**ATTACHMENT A ALL PUBLIC COMMENTS TO IS/MND DURING
PUBLIC REVIEW PERIOD**

RE: Formal Request for Tribal Consultation Pursuant to the California Environmental Quality Act (CEQA), Public Resources Code section 21080.3.1, subds. (b),(d) and (e) INTENT TO ADOPT A MITIGATED NEGATIVE DECLARATION, Oakland Road Industrial Project File No.: H20-018

From: Torney, Lola <lola.torney@vta.org>
Sent: Monday, July 12, 2021 11:44 AM
To: Blanco, Maira
Cc: plan.review
Subject: VTA Comments on Oakland Road Industrial Project (H20-018)

Intersection analysis Oakland/Brokaw

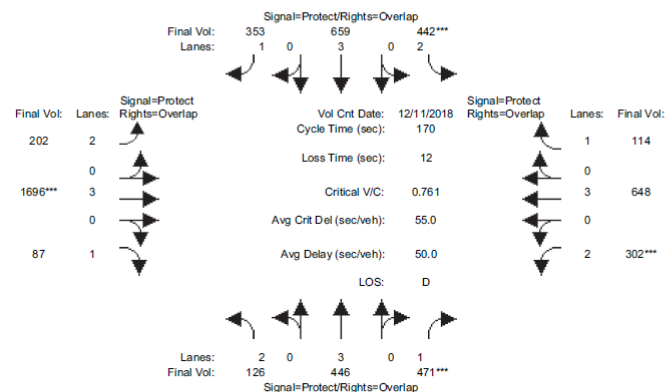
The intersection analysis is incurably flawed as it use unsubstantiated vehicle flow conditions in its modelling, specifically for the eastbound left turn lane from Oakland into Brokaw/Murphy. The model assumes a maximum capacity of 3150 cars/h for the two left lanes combined. Adjusted for a green time of 31.4 seconds per cycle this suggests that the model believes that ~26.25 cars are able to make a left turn per cycle. This is empirically wrong. Based on actual observations on January 29, 2019, a maximum of 16 cars is able to make a left-turn at the intersection per cycle during congested PM peak hour conditions. That means that the model is significantly underestimating the current and future delay at the intersection.

Similar to how the church rejected empirical claims by Galileo and Copernicus because they conflicted with beliefs and previous writings and teachings, it seems likely that the applicant and their traffic consultant will argue that their theoretical modelling based on historic manuals should take precedence over clearly observable empirical fact. This is nonsense.

This commentator is willing to wager \$200 made payable to a non-profit of the City’s choosing, if the applicant, traffic consultant or the City is able to practically demonstrate that 25 or more drivers are able to safely make a left-turn from Oakland Road into eastbound Murphy at this intersection during a 31.4 second green time.
